ARCHITECT'S SUPPLEMENTAL INSTRUCTIONS

PROJECT:	The Residence at Carter Lake New Development Carter Lake, IA	Report No.	Three (3)
OWNER:	OPG Carter Lake Partners, LLC Dan Maximuk 254 N. Santa Fe Ave, Suite A Salina, KS 67401	Date	January 9, 2026
CONTRACTOR:	Koester Construction Company 3050 SE Enterprise Dr. Grimes, IA 50111	Architect's Proj No.	25-3489
		Contract For:	General Construction Mechanical, Electrical

- 1) Contractor to make adjustments as needed and required per the modifications as indicated on attached drawings and in the below descriptions:
 - a. Solar panels, by others, will be installed at the roof. Reference attached revised Sheets A5.1, ME1.2, E1.1, E1.2, and E4.1, for additional information on location, electrical needs, connections, etc.
 - b. Light fixture 'L', (2 total), located above Community Room #124 (reference Sheet E1.1), has been selected by owner/interior designer. Reference the attached "Community Light Fixture" drawing for more information.

2 SECOND FLOOR-ELECTRICAL PLAN
3/32" = 1'-0"

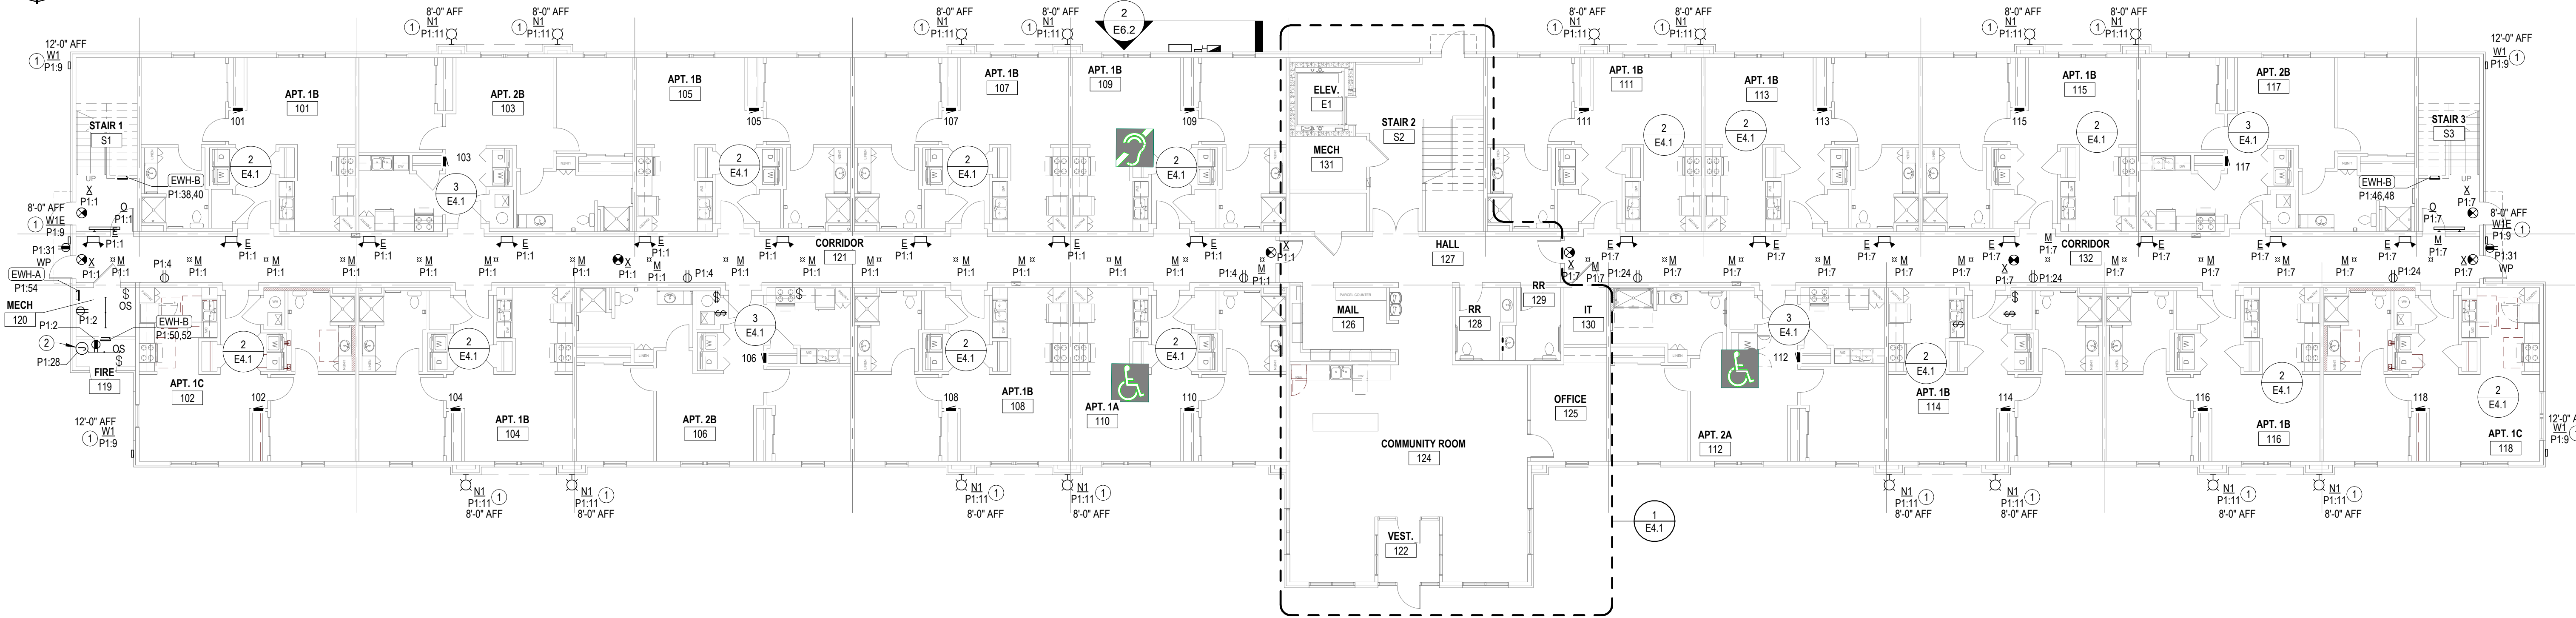
- PROVIDE POWER FOR ELEVATOR SHUNT TRIP CONTROL. SEE 1:E6.1 FOR MORE INFORMATION.
 - ROUTE (2) 1" CONDUITS WITH PULL STRING FROM MAIN ELECTRICAL ROOM TO ROOF. COORDINATE EXACT LOCATION WITH SOLAR PANEL INSTALLER.

M/E ROOF PLAN

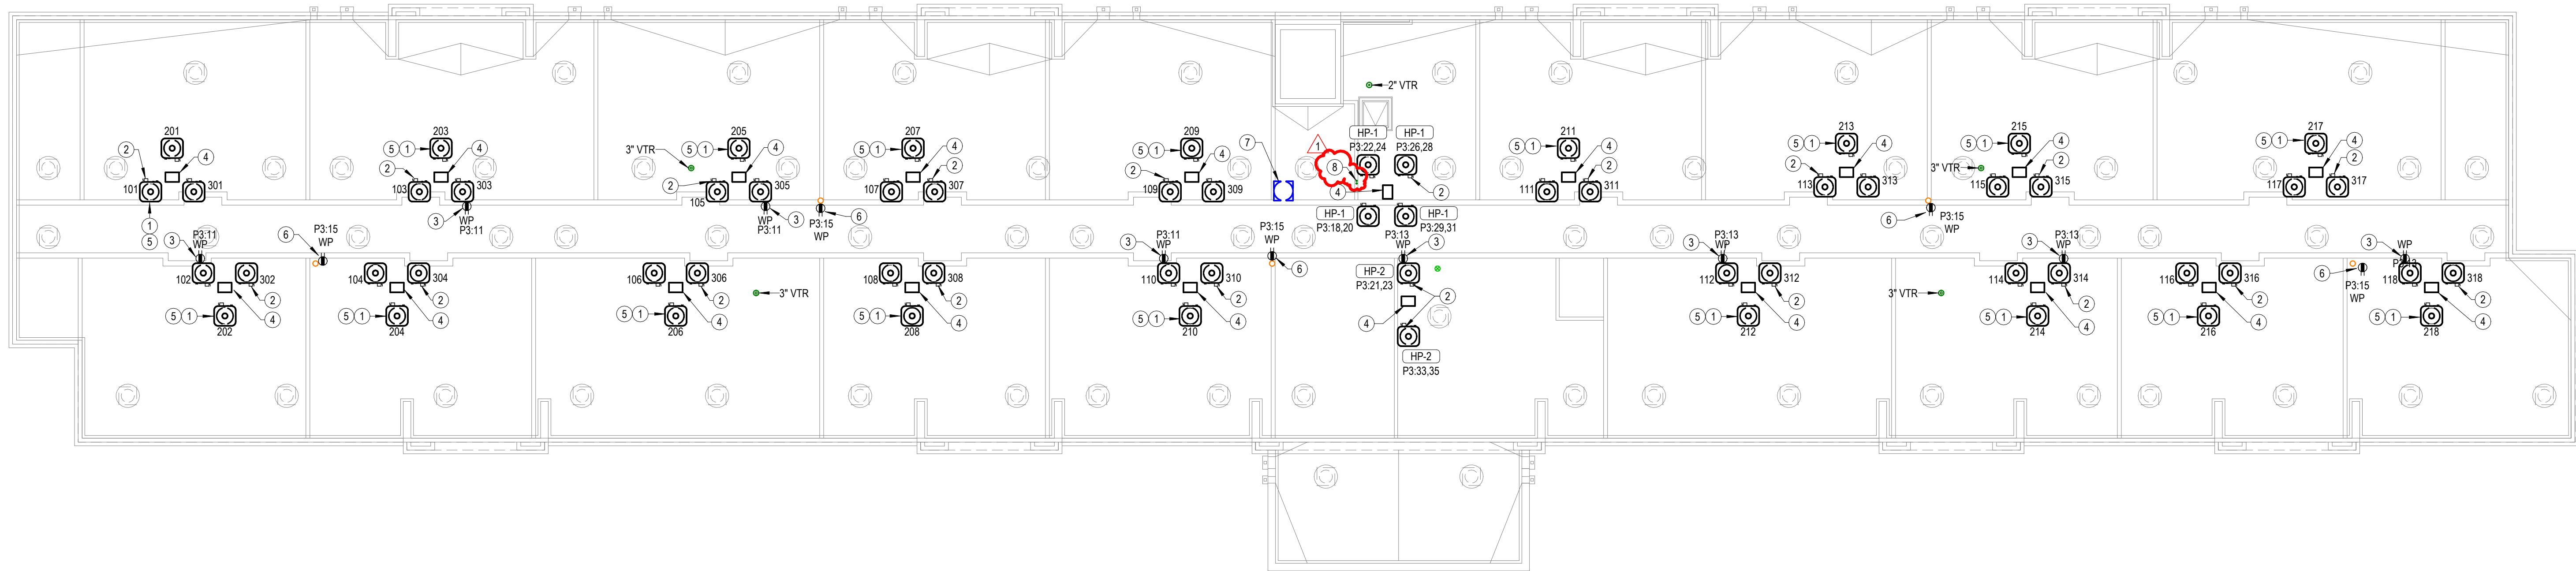
ROUTE (2) 1" CONDUITS WITH PULL STRING FROM MAIN ELECTRICAL ROOM TO ROOF. COORDINATE EXACT LOCATION WITH SOLAR PANEL INSTALLER.
